## **SERVICE LETTER / NOTIFICATION – AUG 28 2020**

Door upgrade

Chris Heintz (CH) STOL and CRUZER CH750

Old style fiberglass door with new aluminum frame on top

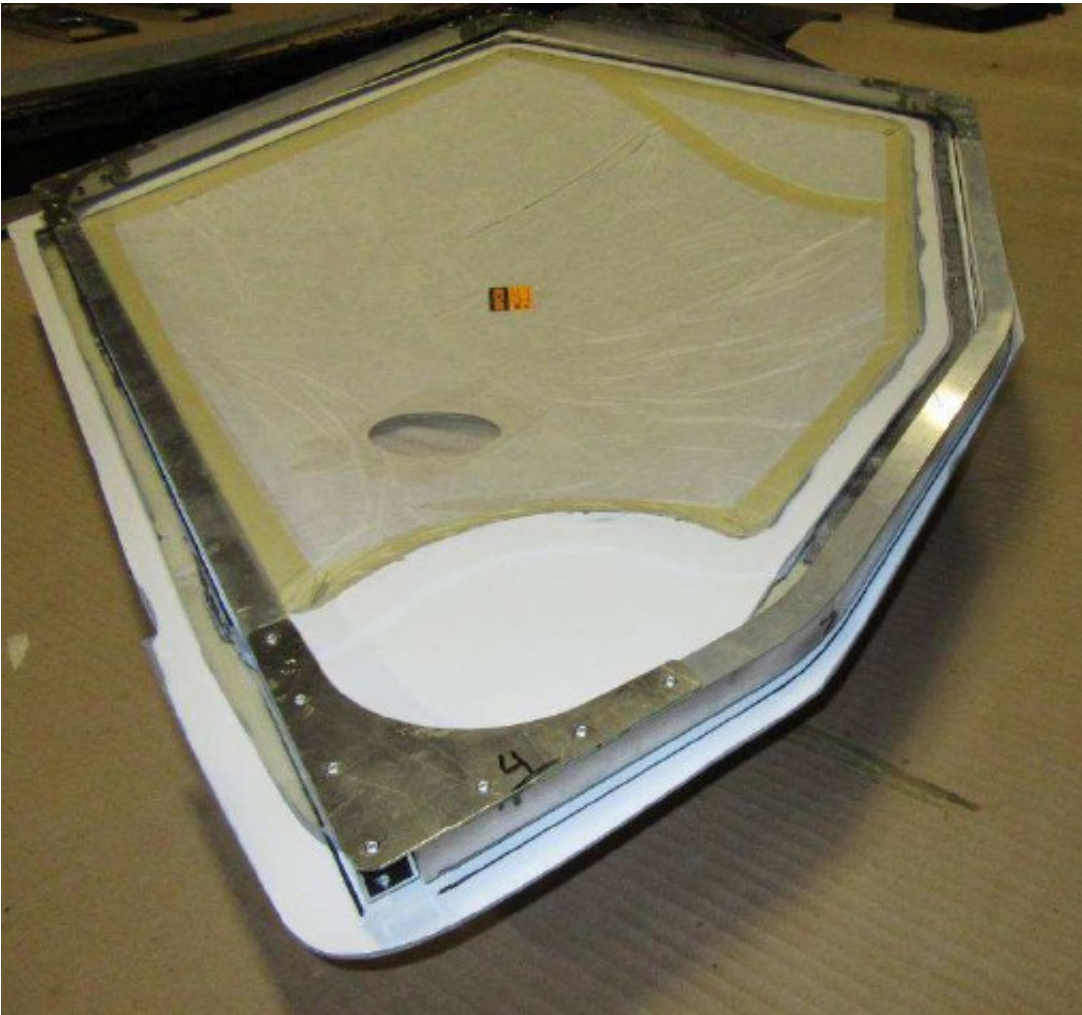
The original STOL CH750 SLSA uses a fibreglass framed door systems for pilot and co-pilot. There continues to be reports of doors cracking in flight on the STOL and Cruiser CH750's.

Photo shows a broken fibreglass door frame.

The original fiberglass door window is the same except the new door has an aluminum frame, making the door stiffer.

Or you can modify your existing fiberglass doors by adding the aluminum frames.

Upgrade to the latest door design – aluminum frame.

When keeping your existing doors and adding the aluminum frame, also view pages 8 and 9 of photo guide C75-NA-1 Section 4 . Upgrade the door frames and everything else as per the STOL CH750 drawings, revision 4. Pages 75-N-1, 75-N-2 and 75-NA-1 and 65-NA-2. Use the Zenair drawings, the photo guides and the Zenair Construction Standards Manual and or FAA 43.13-2A (Aircraft Inspection and Repair).
